Value Engineering Study Report

*Project –NH-018-1(59)
P.I. No. – 621570*

*Widening and Reconstruction of SR 61
From SR 120 Connector
To US 278 / SR 120 / SR 6*

RE: Submittal of the final Value Engineering Report
Project – NH-018-1(59)
Paulding County
P.I. No. – 621570
Widening and Reconstruction of SR 61
PBS&J Project Task Order No. 23

DESCRIPTION: **INCREASE THE USE OF 11' TRAVEL LANES**

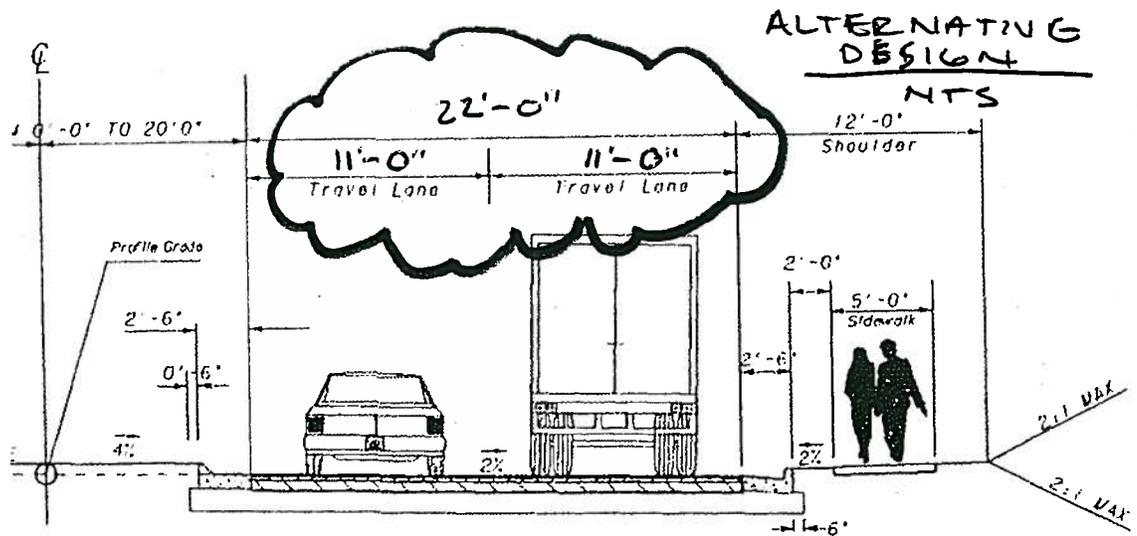
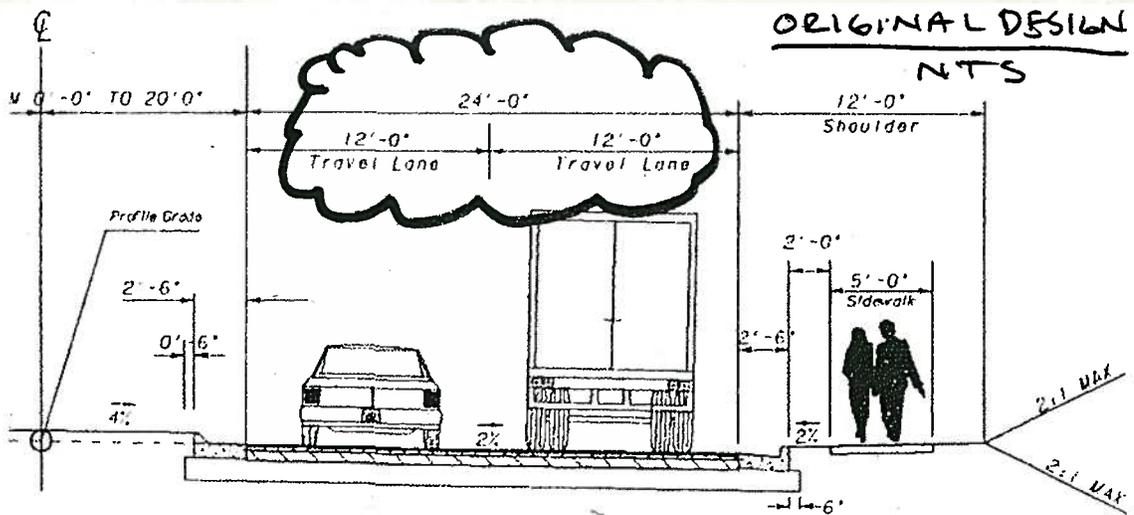
The original utilizes 12'-0" travel lanes throughout the project with the exception of the area in the vicinity of Bethany Christian Church and the cemeteries.

The alternative design proposes using 11'-0" throughout the majority of the project.

Reduction of width of travel lanes throughout the project would result in 4' of full build-up widening that would not have to be constructed, resulting in significant cost savings. Although 11' lanes would require an exception to GDOT policy, AASHTO's "Policy on Geometric Design of Highways 2004" states that 11' lanes are permissible. It also states that under interrupted-flow operating conditions at low speeds (45 mph or less), narrower lanes are normally adequate and have some advantages. (See Pages 472-473). It should also be noted that the designer currently uses 11'-0" lanes for a portion of the project to reduce potential impacts in the area of two cemeteries.

DESCRIPTION: REDUCE SIDE STREET WORK ON SR 120 CONNECTOR.

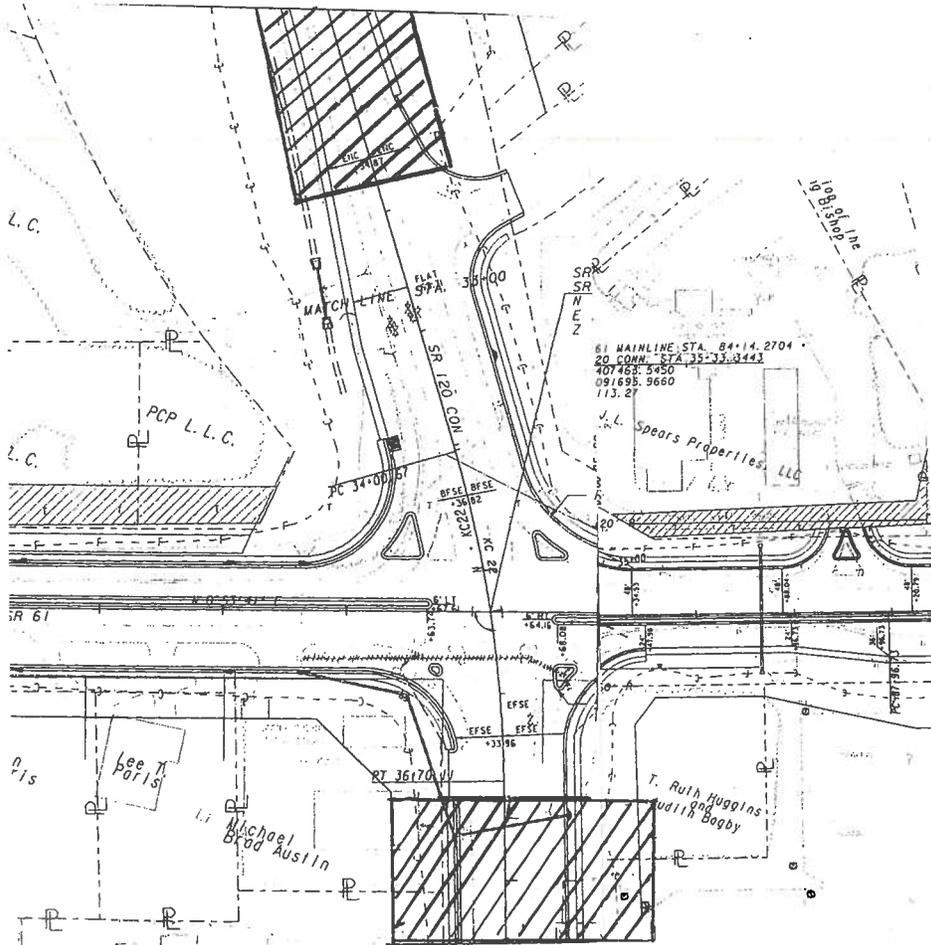
The plans as designed show improvements on the SR 120 Connector for approximately 1,500 LF on the east side, and 1,550 LF on the west side of the SR 61 intersection.

The alternative suggested is to reduce work on the SR 120 Connector alignment, making ties as close to the SR 61 intersection as is practicable.

The intent of the alternative is to reduce the scope of work shown in the plans for the SR 120 intersection and along its alignment on the east and west sides of the SR 61 intersection. Use appropriate drainage ties to existing structures. Maximize side road vertical ties if necessary. Minimize or eliminate obliteration of existing pavement to lower grade if possible. Minimize the overlay length along the SR 120 Connector alignment.

DESCRIPTION: USE 6'-0" PAVED OUTSIDE SHOULDERS IN LIEU OF 6'-6"
PAVED OUTSIDE SHOULDERS SHEET NO.: 2 of 4

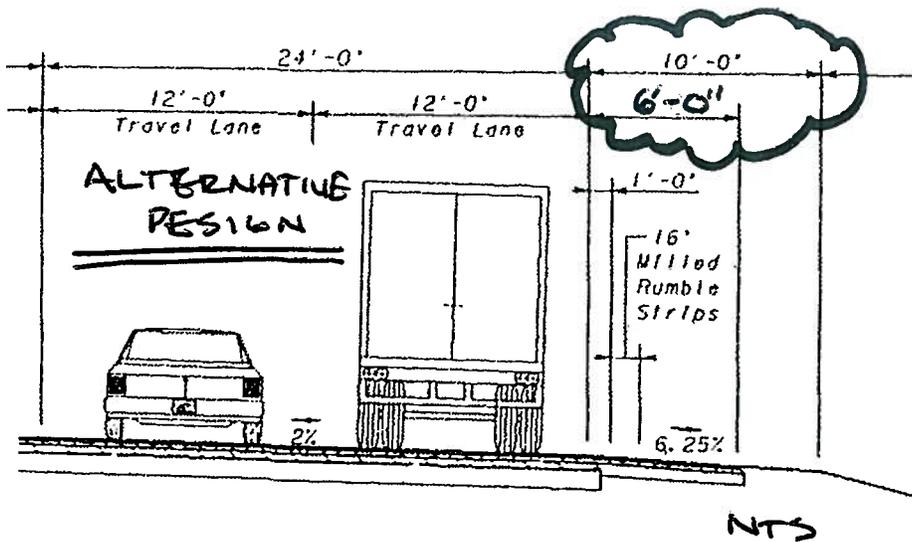
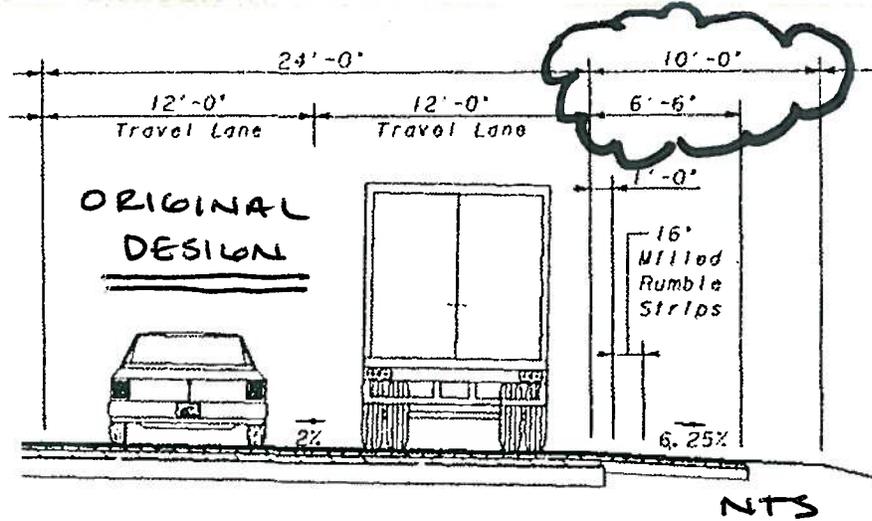
The original design utilizes a 10'-0" improved outside shoulders with 6'-6" of that being paved.

The alternative design proposes a 10'-0" improved outside shoulders with 6'-0" of that being paved.

Since the subject project is not a designated bike route a minimum 6'-6" paved shoulder is not required. Curb and gutter sections of the project have no accommodation for bicycle traffic.

DESCRIPTION: UTILIZE A MORE CONSISTENT TYPICAL SECTION
THROUGHOUT TO PROJECT

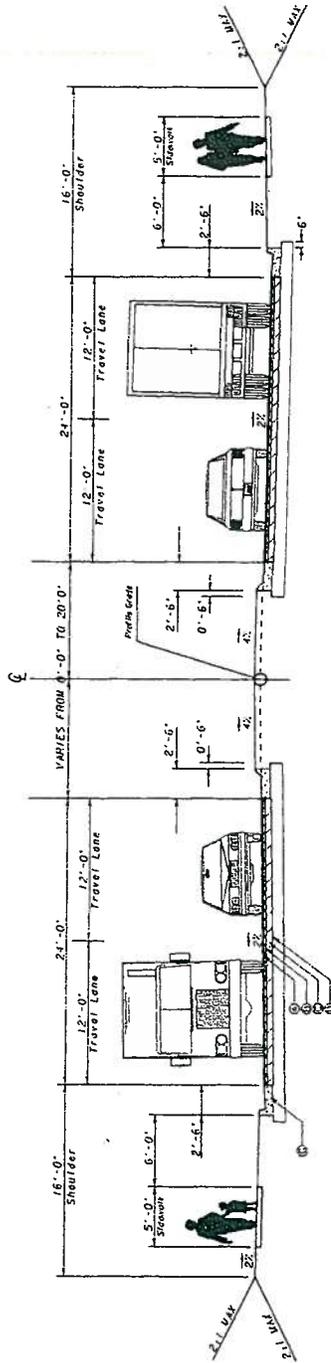
The original design uses a variety of typical sections, curbed with a raised median, curbed with a flush median, outside shoulders with a raised median, outside shoulder on one side with a curb on the other and a raised median, outside shoulder on one side with a curb on the other and a flush median, outside shoulders and a flush median,

The alternative design proposes using more consistent typical throughout the majority of the project. The VE team recommends the use of an urban typical section with curb and gutter and a 20' median (16' raised). The use of an 8 (4' raised) median in the vicinity of the cemeteries may further reduce impacts and the requirements for retaining walls.

The use of an urban typical section with curb and gutter and a raised median throughout the project should provide safety, operational, environmental and economic advantages. The primary advantages will be a reduction in right of way impacts, more consistent access management and a roadway that is less likely to violate "driver expectation" therefore improving safety and operations. The GDOT design team stated that they anticipated having to remove significant portions of the existing roadway with this being the case a curb and gutter roadway could be lowered 1'-3' more than proposed and reduce what appears to be a significant borrow situation. Additional opportunities for cost savings also exist. It may be possible to reduce the required right of way in the roadway relocation from station 160+00 to station 175+00 and retaining walls in the area of the cemetery may potentially be shortened. This estimate does not take into account any damages or displacements that may be reduced in addition to any reduction in wetland impacts..

PROJECT: Georgia Department of Transportation
NH-018-1(59) - P.I. No. 621570
SR 61-Widening & Reconstruction - Paulding County

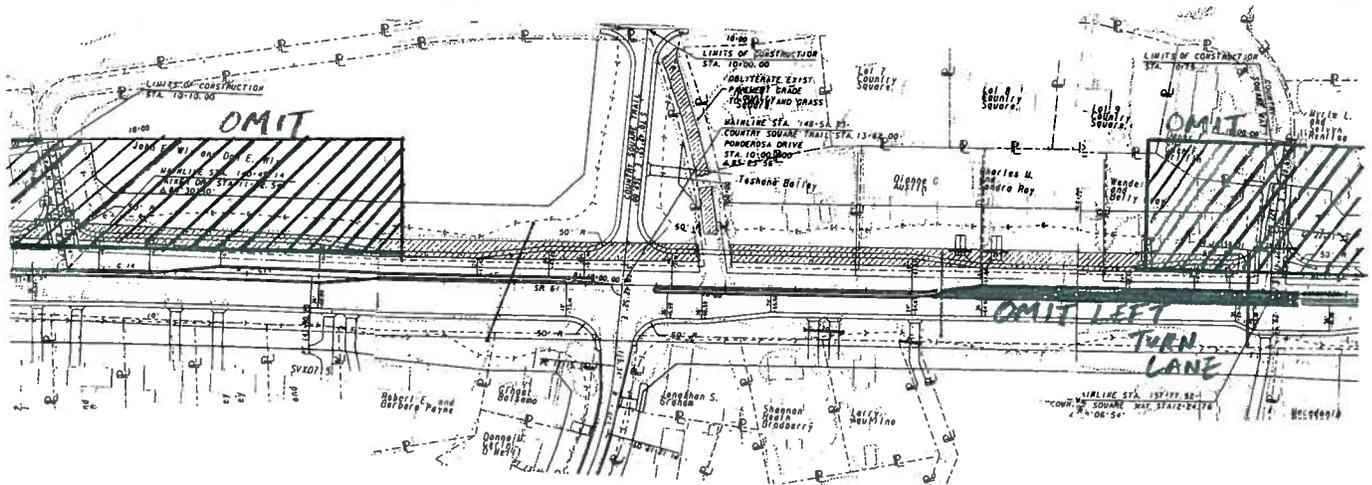
The plans as designed show three intersections on the west side of SR 61 from STA 140+00 to STA 152+00 feeding a small residential development.

The traffic counts for Aiken Drive and Country Square Way are minimal, and with the addition of Country Square Trail as a 4-leg intersection, it may be desirable to channel local traffic west of SR 61 in that area to Country Square Trail. This would result in cost savings by not constructing right and left turn lanes, and not having additional R.O.W. acquisitions to accommodate these planned improvements. Operationally, the traffic low traffic counts would likely make the alternative feasible, and it would be desirable to reduce three intersections to one in a 1,200 LF area.

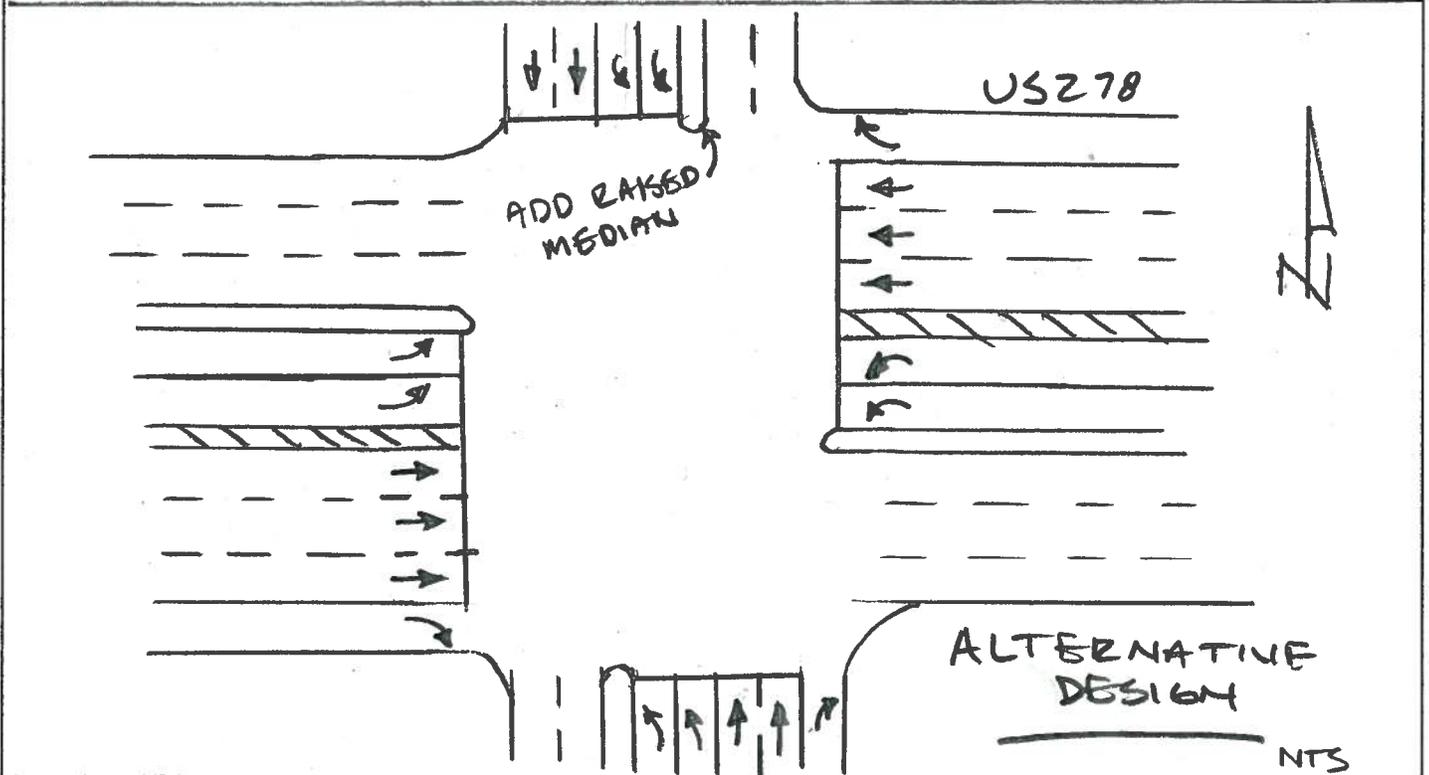
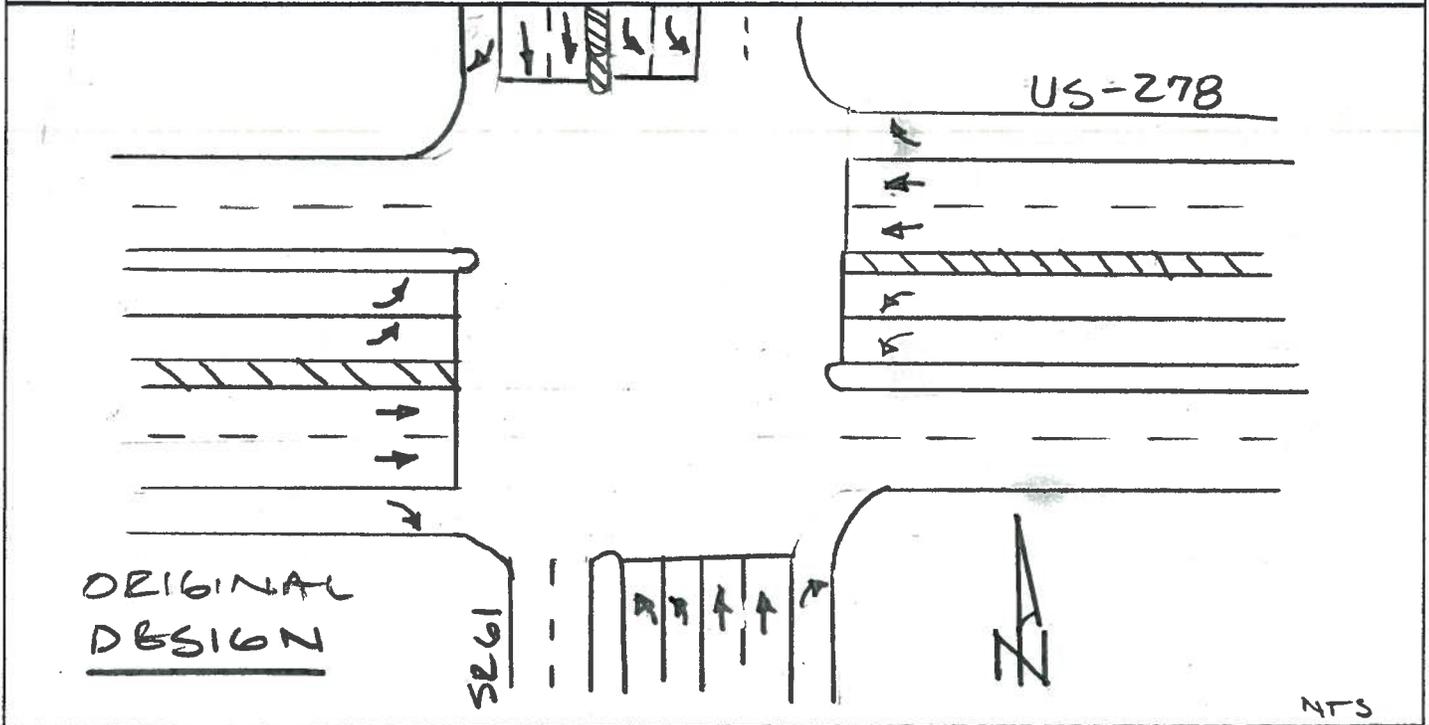
The alternative design proposes widening US-278 to provide three thru lanes each direction at the SR-61 intersection and shorten the left and right turn lanes. In addition it is proposed that the "Type B" left turn offset on SR-61 south bound be eliminated.

The queue of the thru lanes on US-278 controls the required storage length of the left and right turn lanes at the SR-61 intersection. By widening the intersection to provide three thru lanes in each direction the storage lengths can be reduced in addition to reducing the "green time" for the thru movement and improving the LOS of the intersection. Existing right of way appears to be more than sufficient for the wider typical section. Although it appears that the difference in required paving would be insignificant the operational improvement and ease of construction for a future six lane section may be beneficial.

BR-1

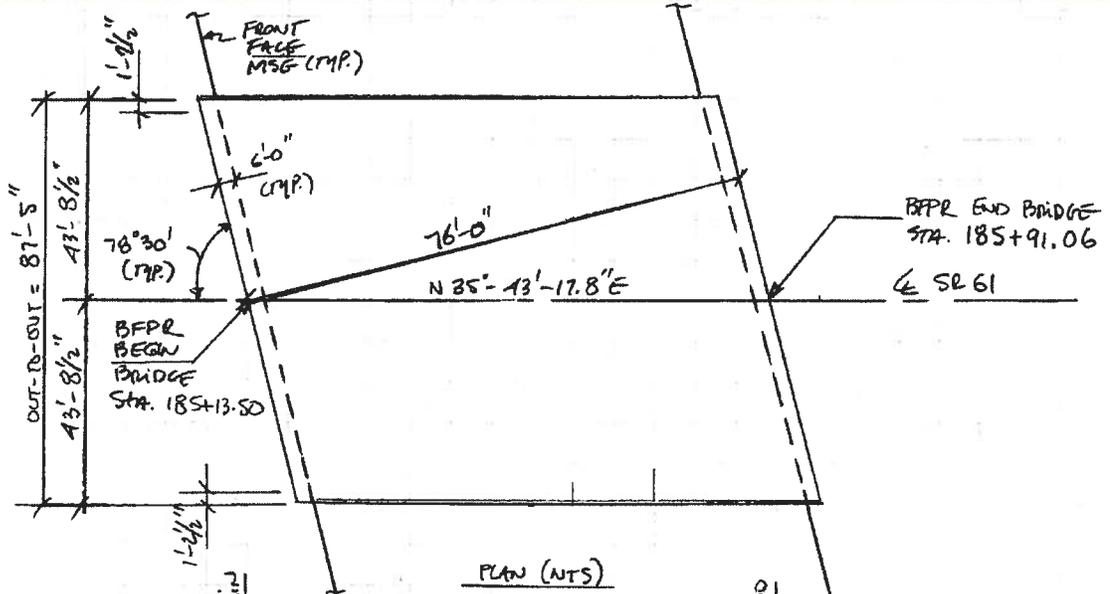
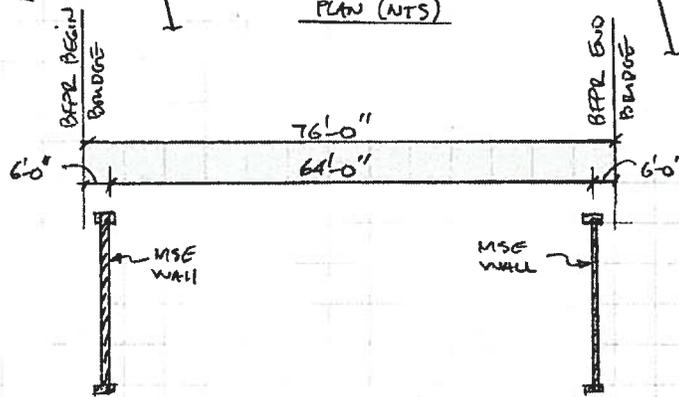
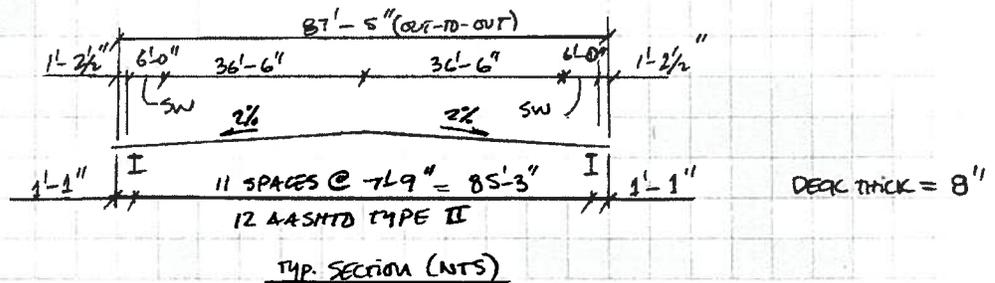
The original design calls for a single span bridge structure to cross over the Silver Comet Trail. The 135'-0" long bridge will have a CIP superstructure supported by 12- PSC 72" Bulb Tees beams spaced at 7'-9". The overall out-to-out width is 91'-3" and it will provide two 6'-0" sidewalks, two 4'-4.5" outside shoulders, 2-12'-0" traffic lanes (each direction), one 20'-0" inside median (with a 4'-0" raised median). The end bents fill will be retained by MSE walls running parallel to the existing trail. The bridge will be on an 11° - 30' skew.

The alternative design calls for a single span bridge structure to cross over the Silver Comet Trail plus a future rail line. The 77'-9" long bridge will have a CIP superstructure supported by 12- PSC AASHTO Type III beams spaced at 7'-9". The overall out-to-out width is 87'-5" and it will provide two 6'-0" sidewalks, two 2'-6" outside shoulders, 2-12'-0" traffic lanes (each direction), one 20'-0" inside median (with a 4'-0" raised median). The end bents fill will be retained by MSE walls running parallel to the existing trail. The bridge will be on an 11° - 30' skew.

USE A 10 X 12 X 100 BOX CULVERT (Ga DOT Sm No. 1324 1/2 AND 2/2)
 w/up to 20' 0" OF FILL (FROM TABLE USE DESIGN 2)

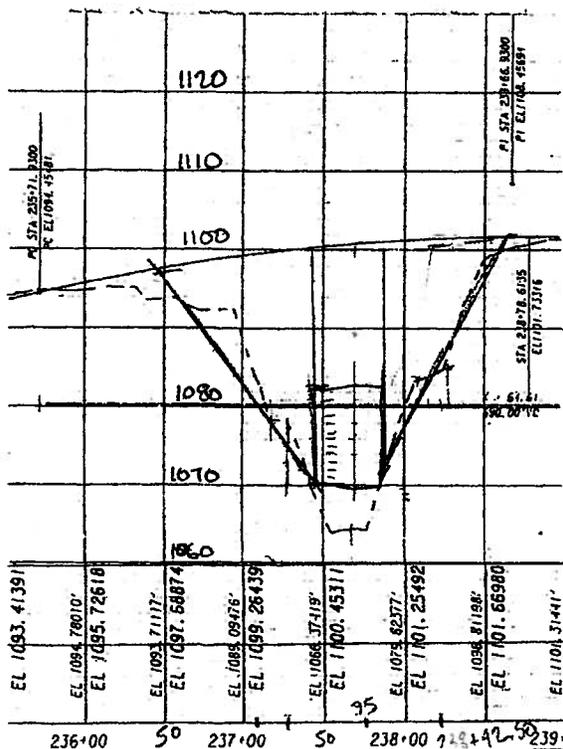
The original design calls for a single span bridge structure to cross over the Silver Comet Trail. The 135'-0" long bridge will have a CIP superstructure supported by 12- PSC 72" Bulb Tees beams spaced at 7'-9". The overall out-to-out width is 91'-3" and it will provide two 6'-0" sidewalks, two 4'-4.5" outside shoulders, 2-12'-0" traffic lanes (each direction), one 20'-0" inside median (with a 4'-0" raised median). The end bents fill will be retained by MSE walls running parallel to the existing trail. The bridge will be on an 11° - 30' skew.

BR-5

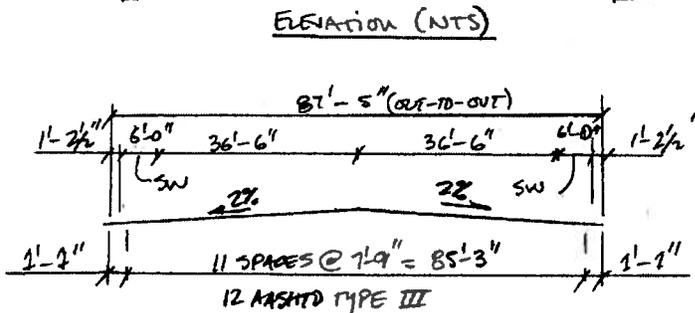
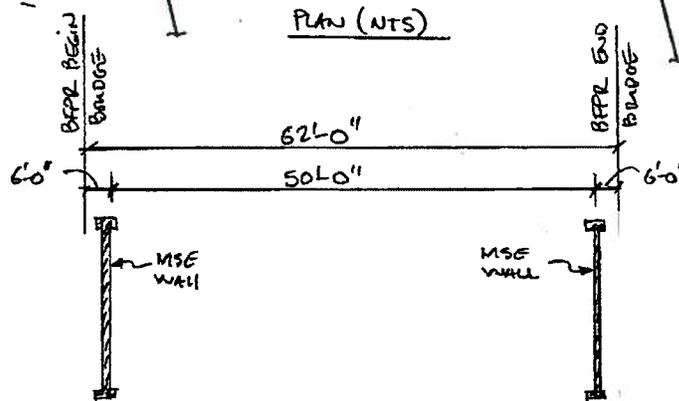
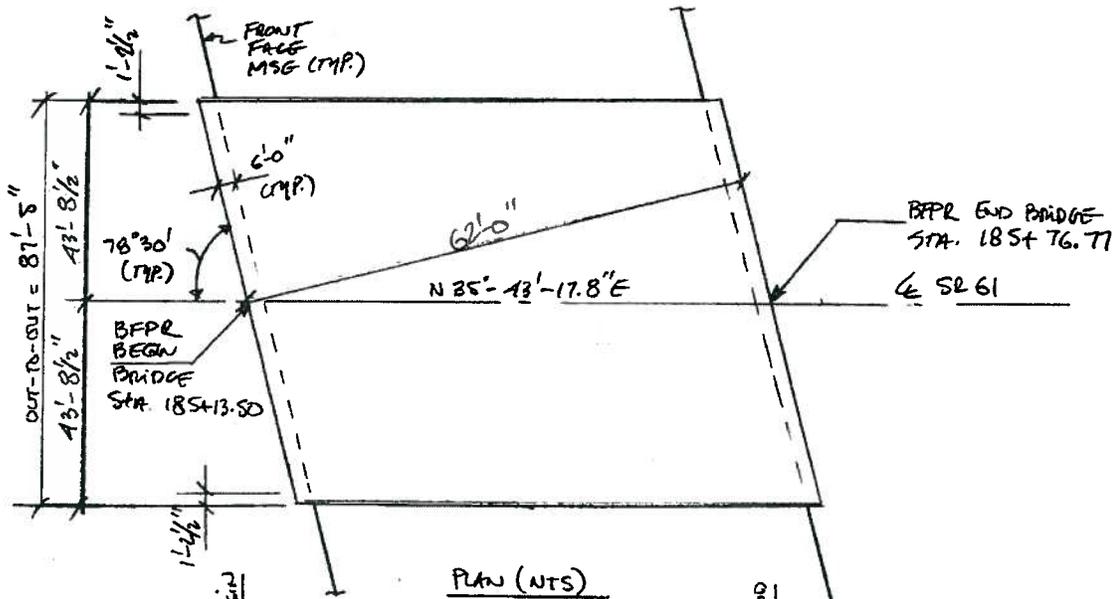
The original design calls for a single span bridge structure to cross over the Silver Comet Trail. The 135'-0" long bridge will have a CIP superstructure supported by 12- PSC 72" Bulb Tees beams spaced at 7'-9". The overall out-to-out width is 91'-3" and it will provide two 6'-0" sidewalks, two 4'-4.5" outside shoulders, 2-12'-0" traffic lanes (each direction), one 20'-0" inside median (with a 4'-0" raised median). The end bents fill will be retained by MSE walls running parallel to the existing trail. The bridge will be on an 11° - 30' skew.

The alternative design calls for a single span bridge structure to cross over the Silver Comet Trail only. The 63'-3" long bridge will have a CIP superstructure supported by 12- PSC AASHTO Type II beams spaced at 7'-9". The overall out-to-out width is 87'-5" and it will provide two 6'-0" sidewalks, two 2'-6" outside shoulders, 2-12'-0" traffic lanes (each direction), one 20'-0" inside median (with a 4'-0" raised median). The end bents fill will be retained by MSE walls running parallel to the existing trail. The bridge will be on an 11° - 30' skew.
